**Dubbo Quarry Continuation Project (SSD-10417) –
Environmental Impact Statement (EIS)**

Advice to DPIE Planning & Assessment regarding the Dubbo Quarry Continuation Project (SSD-10417) – EIS

Further Detailed Groundwater Take and Impact Modelling / Analysis Advice regarding the Dubbo Quarry Continuation Project (SSD-10417) – EIS

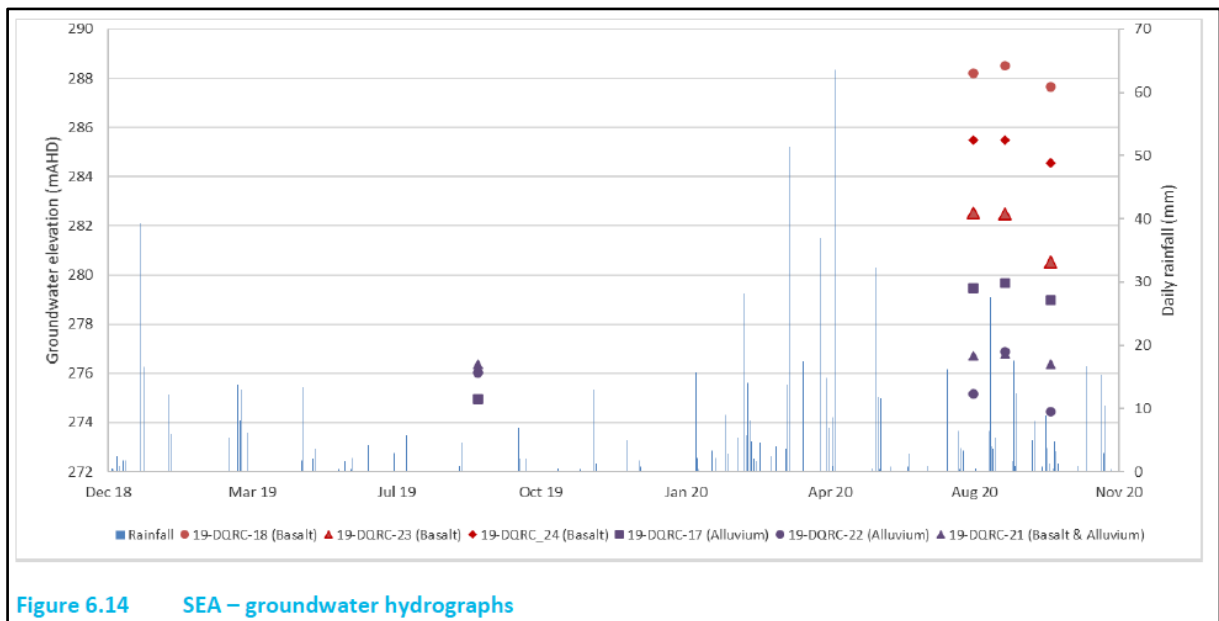
Estimated changes to groundwater inflows as a result of “allowing the East Pit to partially fill and by maintaining a pit water level that generally restricts groundwater inflows” are significant. Inflows are estimated to reduce from 181 ML in a median year, to just 19 ML. Insufficient evidence has been provided to support this conclusion.

The recharge mechanism described indicates that groundwater could potentially flow into the mine pits during and after rainfall events due to a combination of unsaturated flow and short-term increases in the water table. Groundwater level monitoring data is presented in **Figure 6.14** of the EIS and is reproduced below. It shows water levels in bore 19-DQRC-18 (screened in the basalt) at around 288 mAHD which is higher than the proposed base of the SEA of 286 mAHD.

The proponent needs to provide more evidence to support their assertion that the pits will not intercept the water table or take groundwater via unsaturated flow during rainfall events. The proponent must also provide more evidence as to how they intend to increase the catchment area of the Quarry operations by approximately 26 hectares yet reduce groundwater inflows from 181 ML to 19 ML.
